825 NORTH BROADWAY WHITE PLAINS, NY 10603 (TOWN OF NORTH CASTLE)

AUTOMOBILE SERVICE STATION ALTERATION (GAS TANKS REPAIR AND CONVENIENCE STORE INTERIOR ALTERATIONS)

We have revised the plans to answer the May 20, 2022 comments from the Town Consulting Engineering John Kellard, P.E. as follows (**in bold**):

PROPOSED GAS STATION

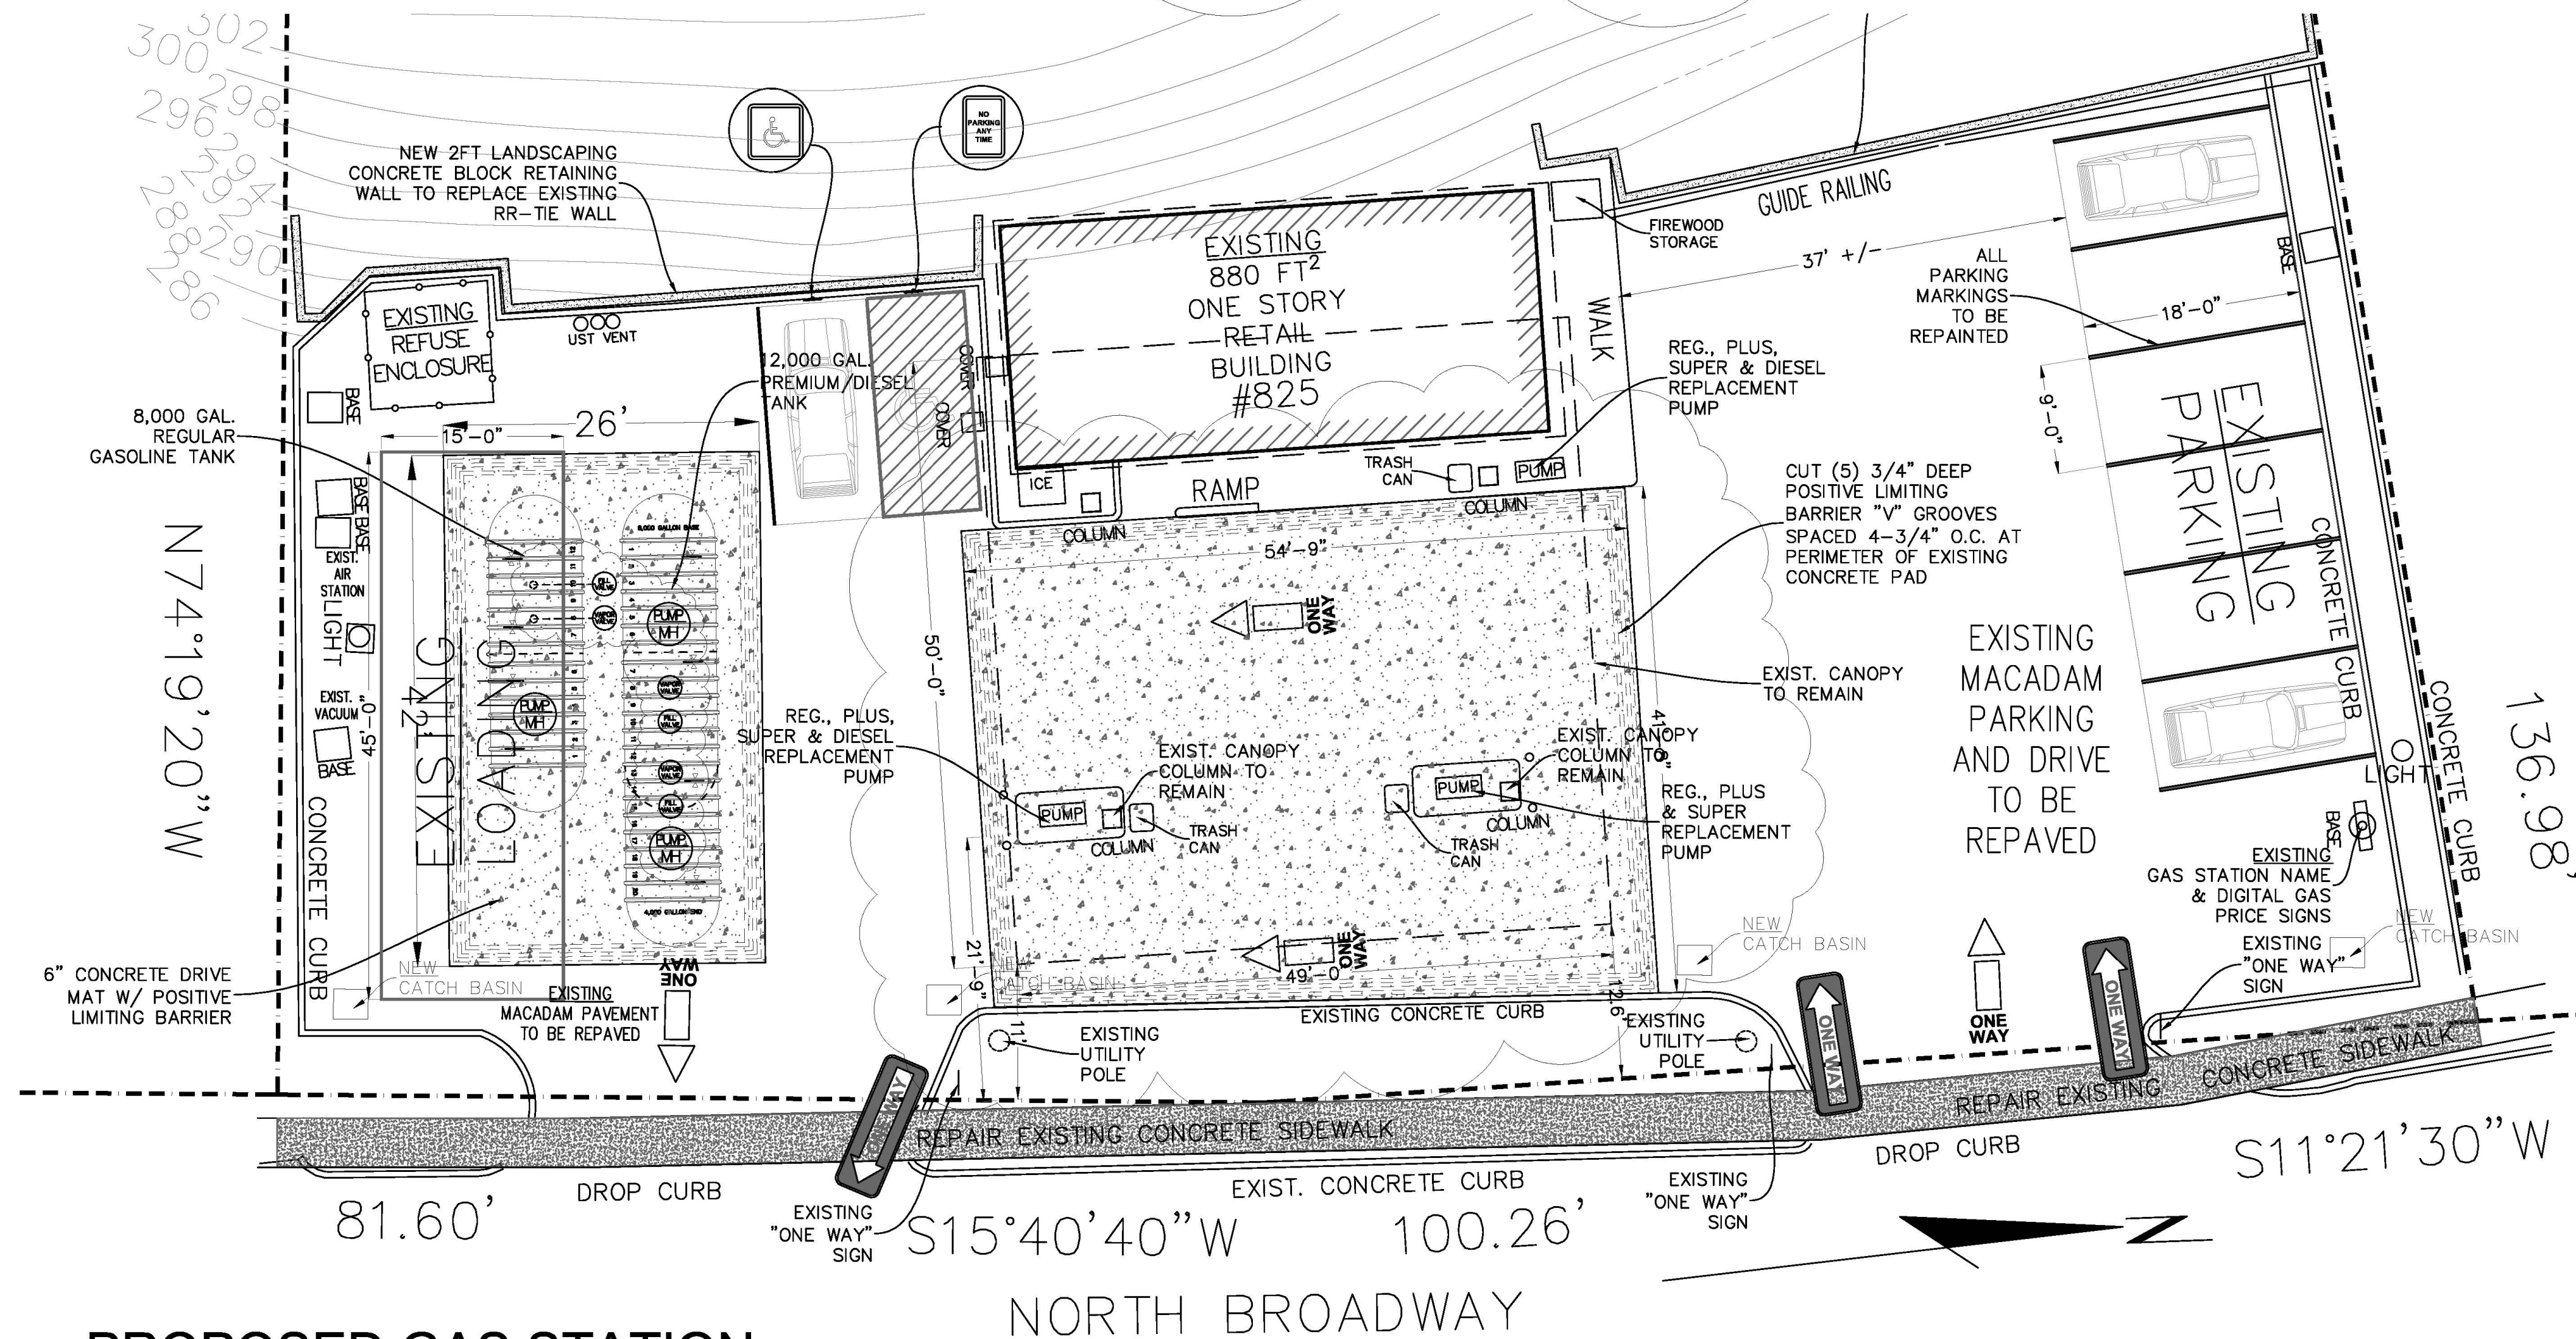
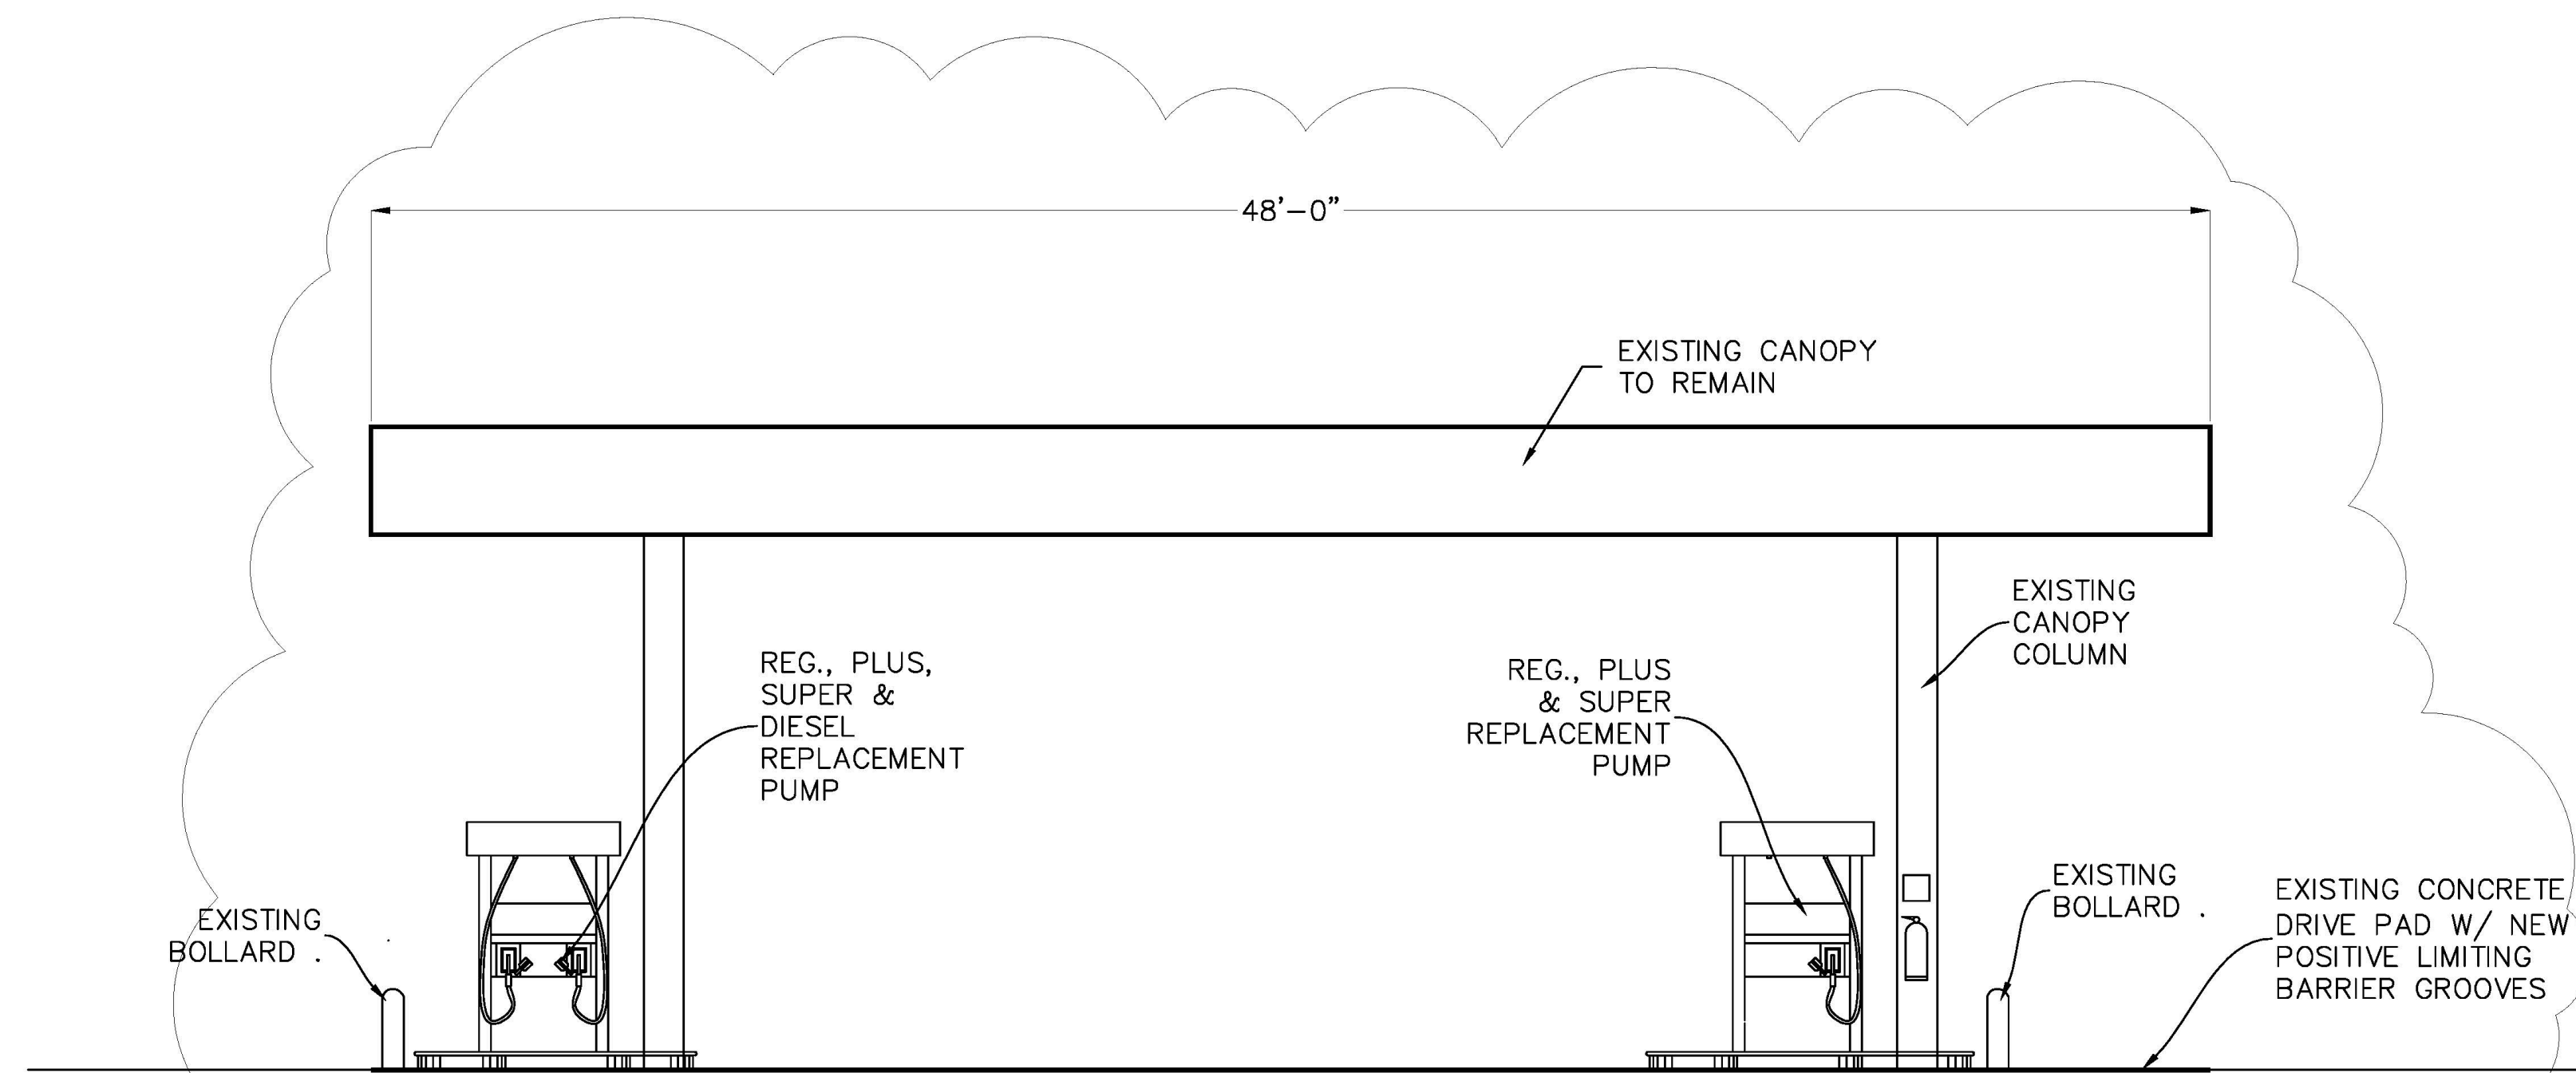
2. A truck loading space is provided along the southern portion of the site, which would be used by the fuel delivery truck when filling the new underground tanks. The loading space is located directly over the 8,000 gallon tank. The applicant should show the locations of the fill lines, avoiding locations within the loading space or within the drive aisle.

3. The site plan should be revised to clearly depict existing and proposed dimensions of the canopy.

New UST Manholes, fill valves and vapor valves added to plans on page G3. Fill and Vapor valve shown outside of loading space for 8000 gal. UST.

The dimensions of the new canopy were added to plans.
